VILLAGE OF WARWICK ZONING BOARD OF APPEALS AGENDA

Re: Petition of Stephen Gross

Property Address: 62 Colonial Avenue

Altstadt Residence

Drawn By: cc Checked By: cjpc Drawings on this page: Landscape Plan

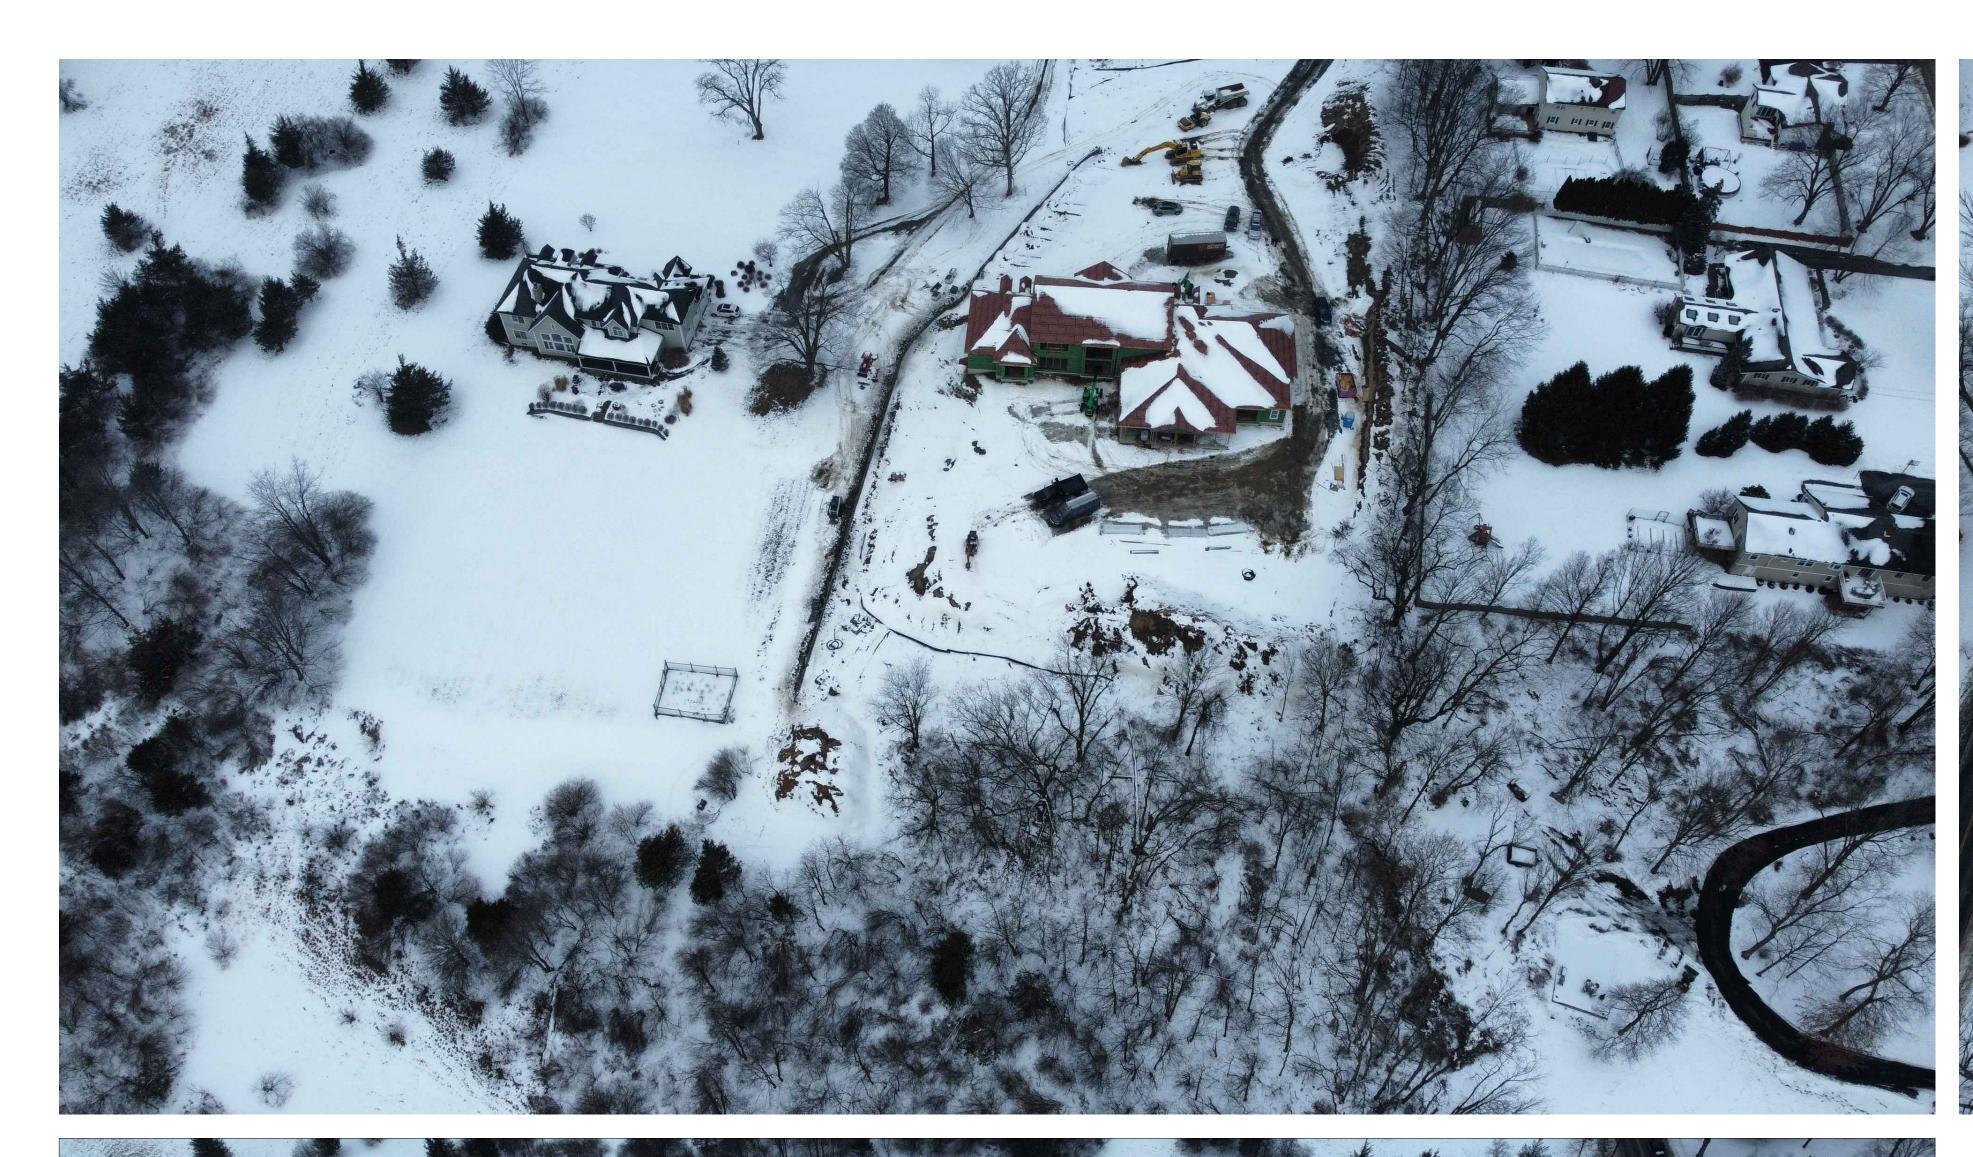
Rear clearing limit line to match adjacent property owners (Schafer, Craig 60 Colonial Avenue, 208-1-14) Depiction of area along Schafer's

Existing driveway culvert for #62 Colonial Avenue to be connected to the county drainage system as per the request of Orange County.

Tree layout staggered as per recommendations by David Griggs, ERS Consultants via letter dated January 5, 2022 (attached here)

driveway requires regraded to eliminate ponding. Letter of permisson obtained from Mr. Schaffer.

Headwall to be removed and a catch basin added, also at the request of the county.

Limit of grading and retaining wall(s) along Easterly property line depicted.

- 1) Ruts in wetlands restore ruts/tracks by hand to avoid further disturbance to wetlands. Lightly tamp down any high portions of the tracks to match the surrounding wetland elevation 2) Shrubs in wetlands disturbed – plant ten (10) red osier dogwood
- (Cornus sericea) shrubs. Shrubs should be 18-24 inches in height to be planted randomly within the wetland area. 3) Once underground utilities are in place, remove excess fill in

It is recommended that the landscape plan include only native plant species. Planting native plant species will create the most sustainable habitat, require less watering, and are the most familiar food and shelter for local birds and wildlife. The current site plan shows the planting of native white spruce (Picea glauca) and native American arborvitae, (Thuja occidentalis). It is recommended that they stagger the plantings instead of a straight line, which will provide more privacy, won't restrict plant growth and appear slightly more

Dave Griggs Comments responding to above by Email - Meeting Notes Jan 5, 2021 I reviewed your notes from our meeting in November and the landscape plans and I have a few comments: No topsoil should be placed into the wetlands. Just have the contractor push, by hand, the high spots into the ruts and level it as best as possible. The arborvitaes are fine as long as they are native, Thuga occidentalis occidentalis, not a variety. Same with the white spruces, native is best. I would stagger them for a more natural look, more privacy, and it allows the trees to grow better. I have attached an invoice for my services. I included the two meetings as well since Boris

- 1. With respect to the 25-foot area east of the boundary lines where no trees are to be cleared, the property owner will be planting 22 native white spruce and an additional row of native arborvitae at the end of construction for additional buffering. As discussed at the last meeting, two trees were removed because of their poor condition. In the event a tree needs to be removed due to disease, the property owner will consult with the shade tree commission prior to removing the tree. I also note that the 25' perimeter area is restricted to tree cutting only. There is significant detritus in that area such as fence remnants, old garden tools and general junk which the owner plans on removing. A new perimeter fence will be installed to replace the existing and dilapidated hog wire fence. Again, no trees will be disturbed.

- 2. After consulting with the neighboring property owner of 60 Colonial Avenue, the Altstadt's contractor has been given written permission to grade in the area of the neighbor's driveway. Such grading will bring the finished grading in line with the original subdivision approval and will eliminate ponding in that area. Grading work will be completed as approved by the Village Engineer.

- 3. The wetlands have been restored per David Grigg's instructions. The owner will likewise maintain the wetlands as instructed.
- 4. The property owner has included a proposed tree clearing line in the rear yard. The proposed tree line is consistent with the tree line of the adjoining property. Any tree removal would be subject to approval by the Shade Tree Commission.

- 5. The location of the necessary retaining walls has been added to the plans.
- 6. At the request of the Orange County Department of Public Works, the existing driveway culvert will be connected to the existing county drainage system. The existing headwall will be removed, and a new catch basin will be installed to correct the improper grading and poor drainage.

10. Locations for Landscape Block retaining walls added. 11. Septic line location revised to adjacent to existing utilities.

Arborvitae graphic depiction corrected.

Retaining wall on Western side of property depicted.

New pool location depicted.

New plantings revised.
